ADDENDUM NO. 003

RE: Long-Term and Short-Term Parking Lot Reconfiguration
Roanoke Regional Airport Commission
T&L Project No. 15175
RRAC Bid No. 20-002

DATE: December 30, 2020

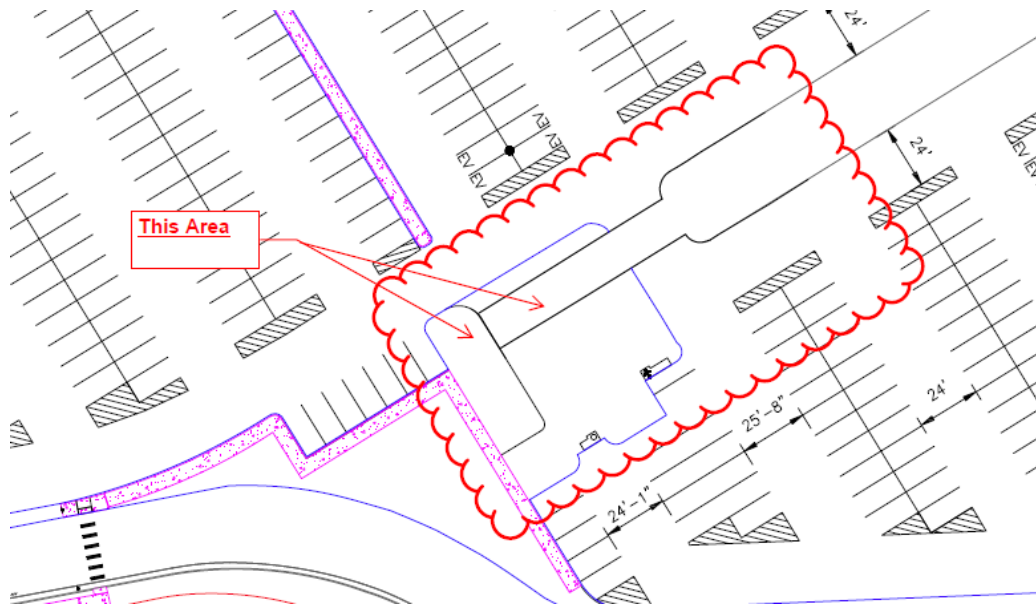
1. QUESTION: Clarification requested on what is being installed in the area highlighted on the attached drawing.

RESPONSE: Nothing is being installed at the areas where the arrowheads are pointing. That is the existing concrete walkway area.
